ADDENDUM NO. 3

Date: May 24, 2019

Project: Cherokee Mental Health Institute
Tunnel Repairs
DAS RFB 0919335132
DAS Project 9072.00

Sheet S1.04

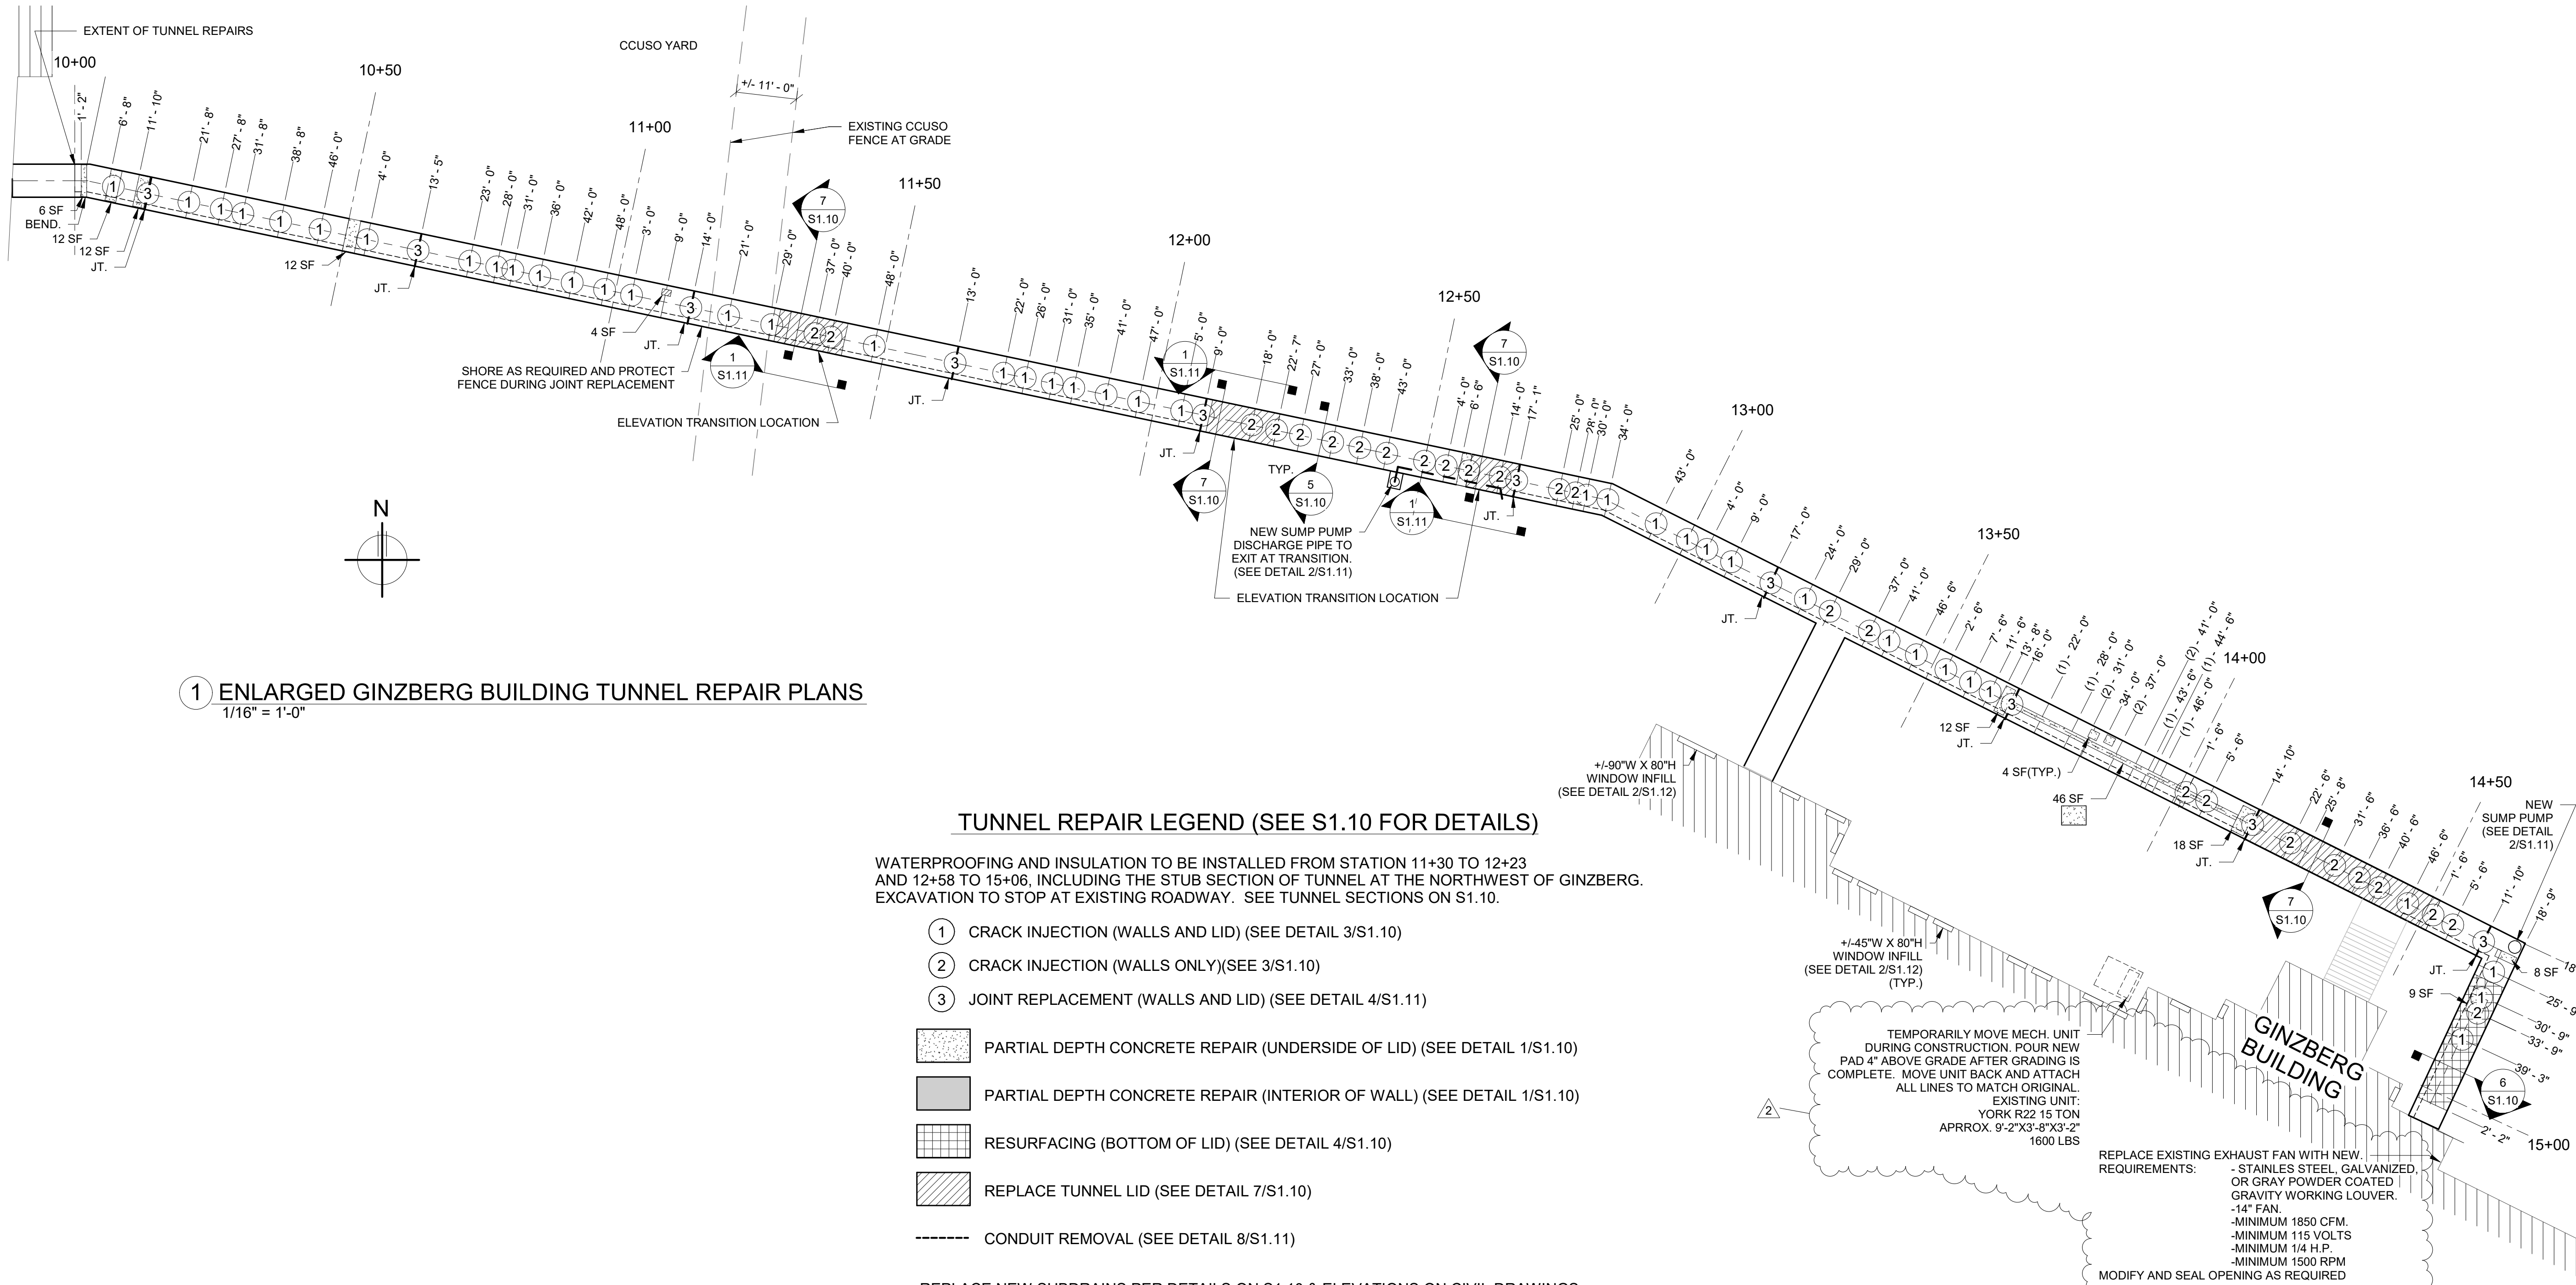
1. **DS1.02** – Add "There is not a separate sidewalk on top of the Ginzberg tunnel lid. The tunnel lid is the current sidewalk."
2. **S1.03** – Modify exhaust fan replacement requirements.
3. **S1.04** – Modify exhaust fan replacement requirements.
4. **S1.04** – Add existing mechanical unit information.
5. **Detail 2/S1.11** – Delete "Steel Grate" note.
6. **Detail 2/S1.12** – Add brick requirements.
7. **Detail 2/S1.12** – Add alternate bond beam option for CMU installation.

4. Will the owner be paying for the NPDES Permit #2.
5. Sheet S1.04 calls out for (3) tunnel joints to be replaced in the CCUSO yard but the ramp is not to be removed, there will also be holes next to the walks 7' deep x7' wide x6' long on each side for the work. Ramp may be temporarily relocated during construction.

6. Sheet S1.03 call out Replace existing exhaust fan with new at the Voldeng Hall corner, on the tour the only fan was at the Ginzberg tunnel entrance also shown on Sheet S1.04. The fan is located in a fenced in room at the end of the tunnel and was shown at the end of the visit.

2 TYPICAL SUMP PIT DETAIL
1" = 1'-0"

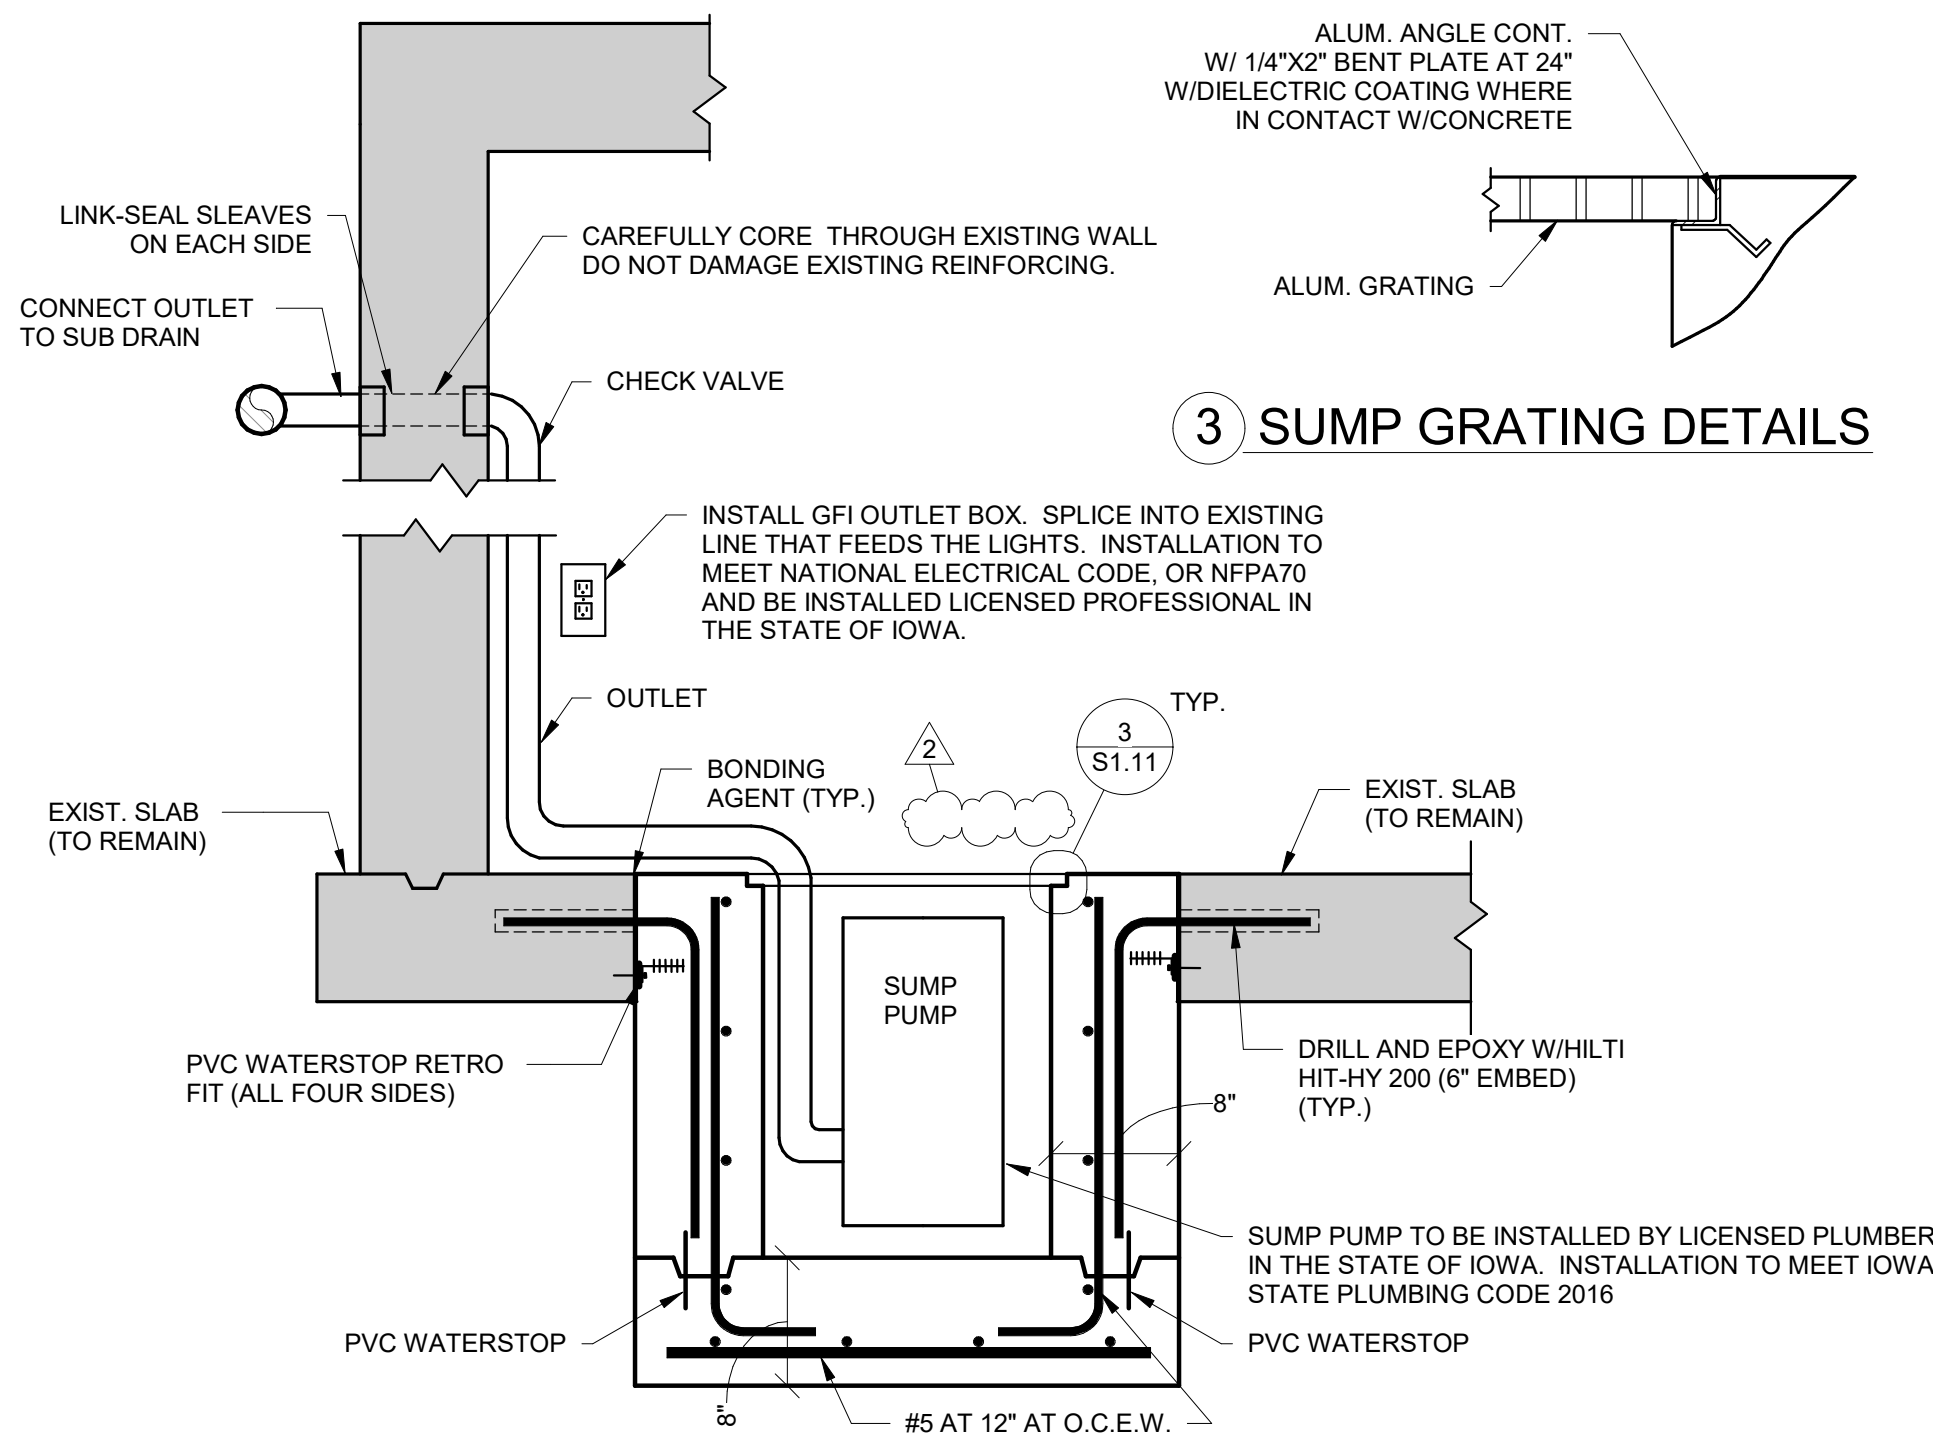
8. Sheet S1.11 Detail 2 calls out sump pit grate, is there a manufacturer or brand, is this round, what is the thickness required. Does it have to be aluminum, there are hundreds of premade steel, poly & plastic grates and frames available made for sump pits. Grating to be aluminum per the plans.
